RCSC Middle School **Natatorium HVAC & Lighting Upgrade**

Project # 2023.0011

05-20-2024

ADDENDUM NO. 01

TITLE
Reflected
Ceiling Plan &
Details
SHEET

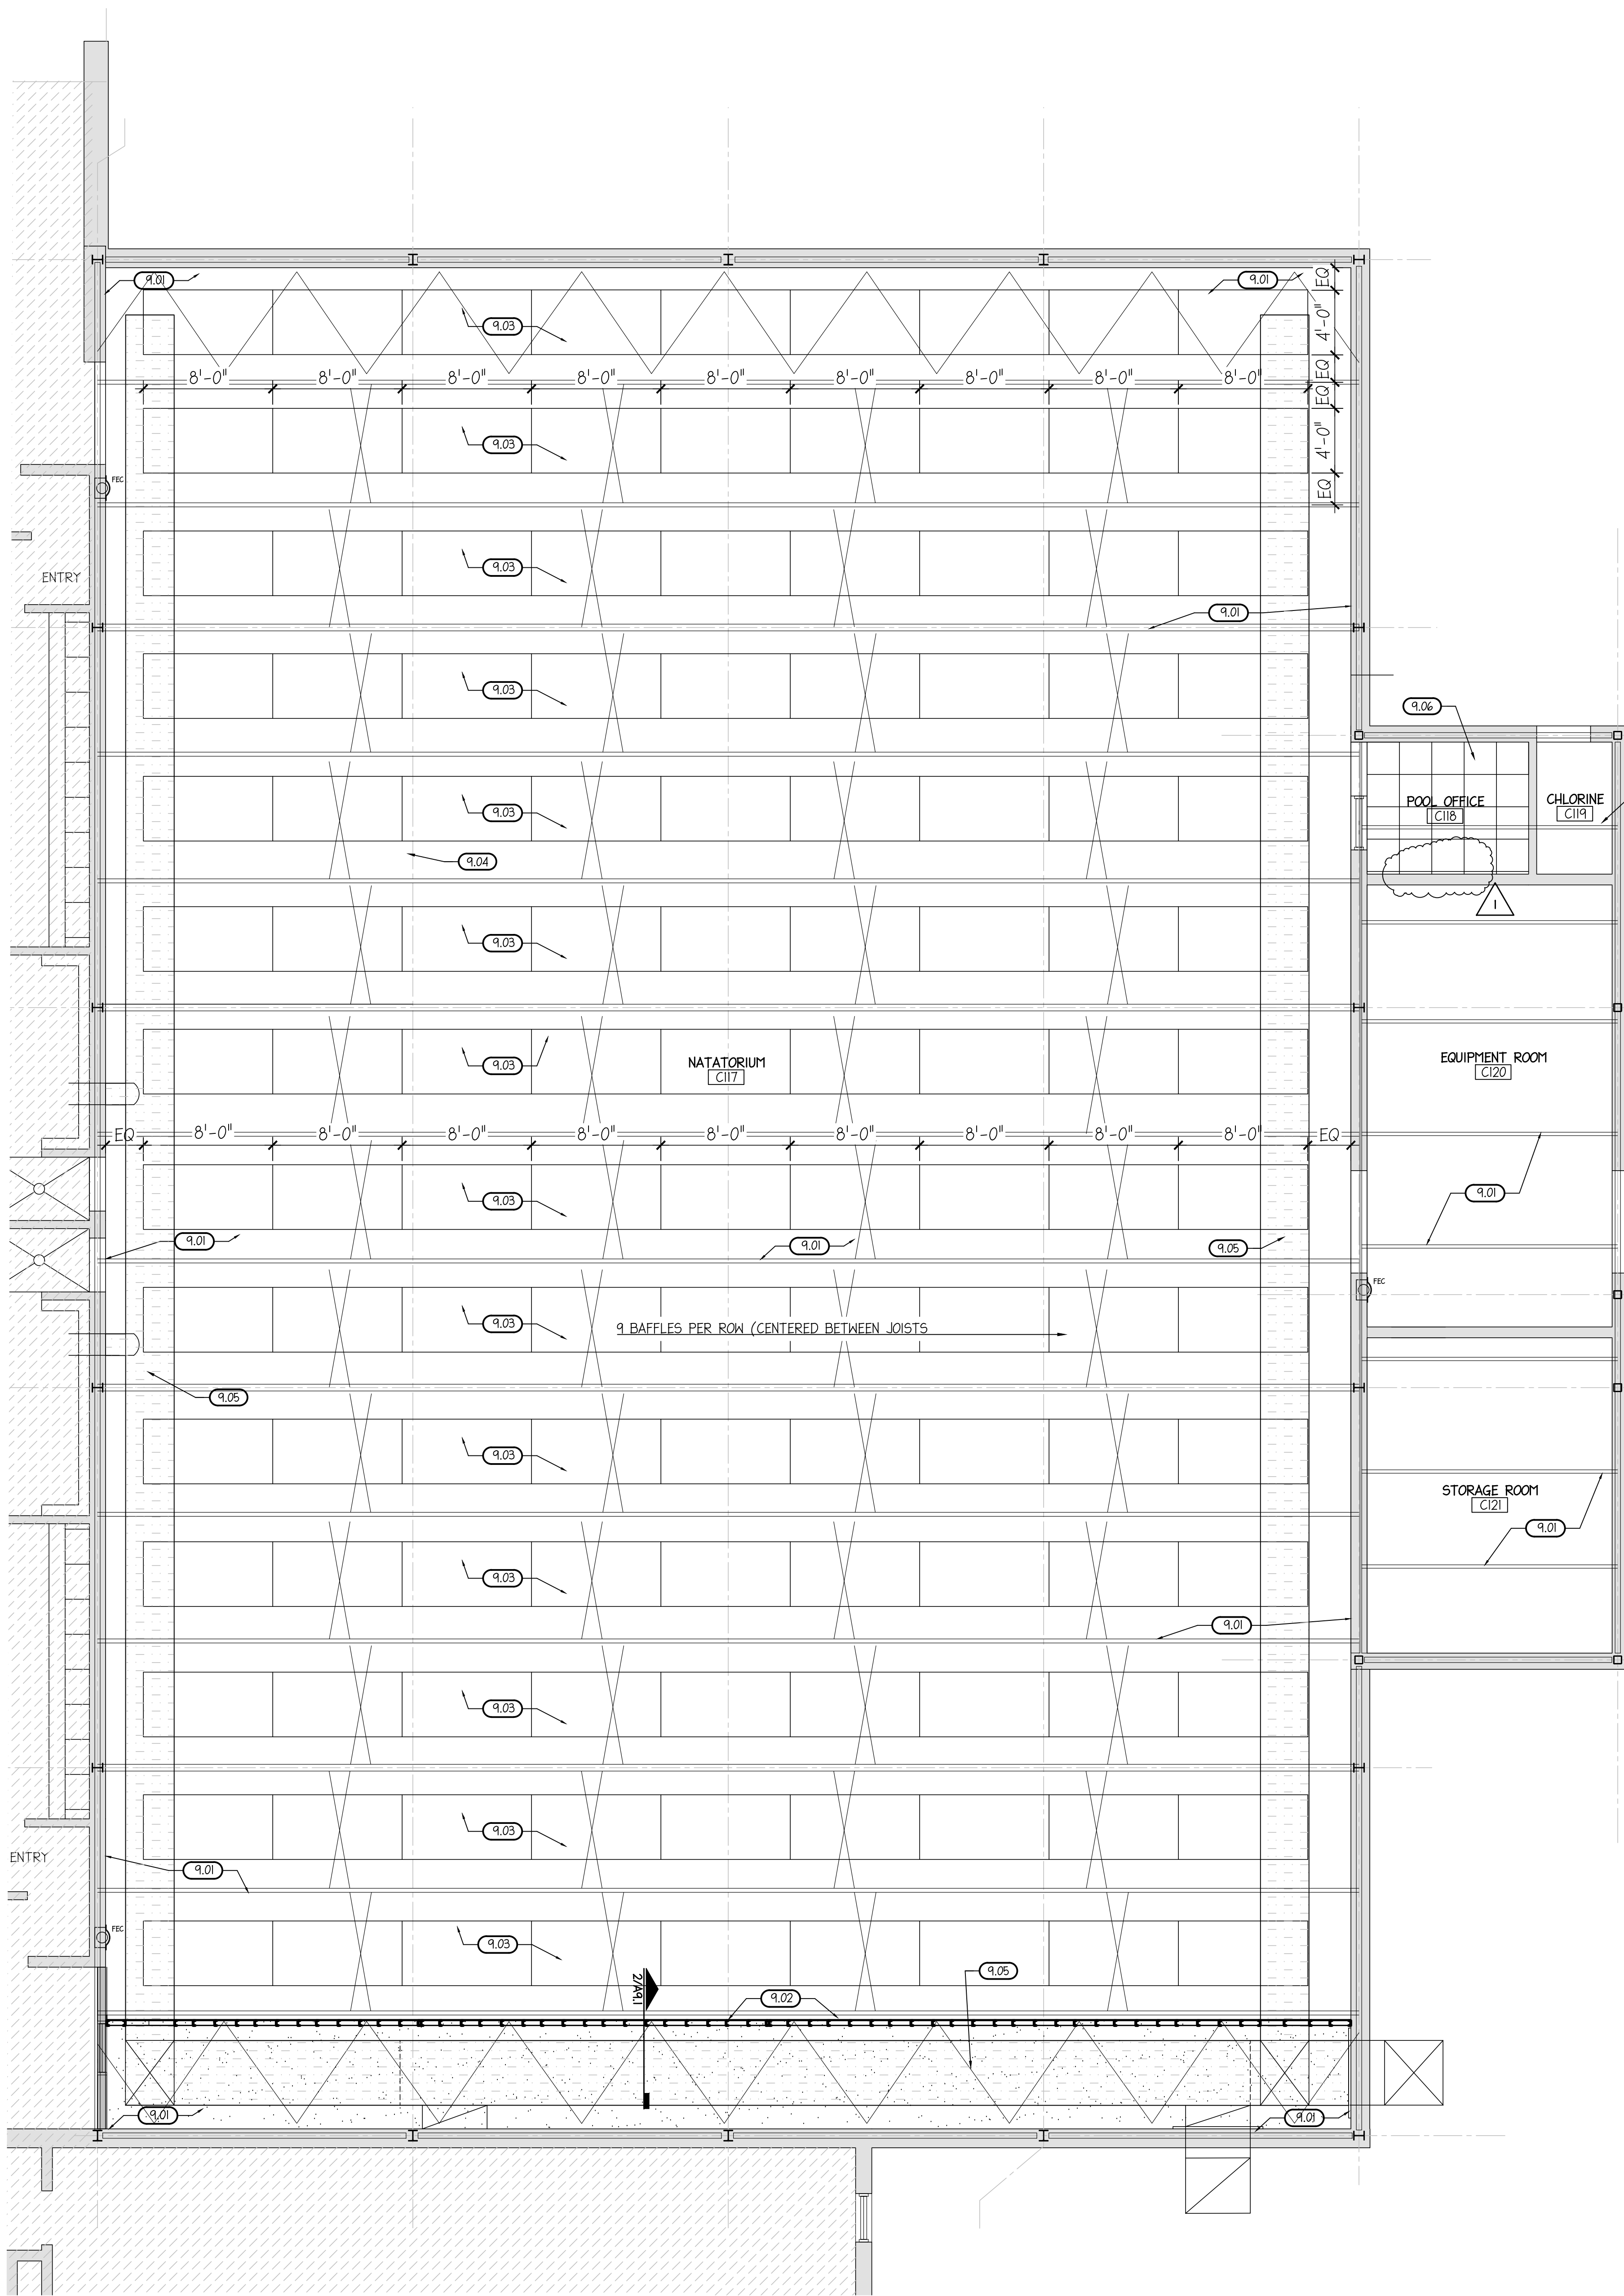
Item: **A-1.8**
Location: A9.1 Reflected Ceiling Plan & Details
Description: Replace drawing dated 05-01-2024 with drawing marked Addendum 01, dated 5-20-2024

1. Removed note and detail for suspended gypsum ceiling in office.
2. Updated detail 2 / A9.1.
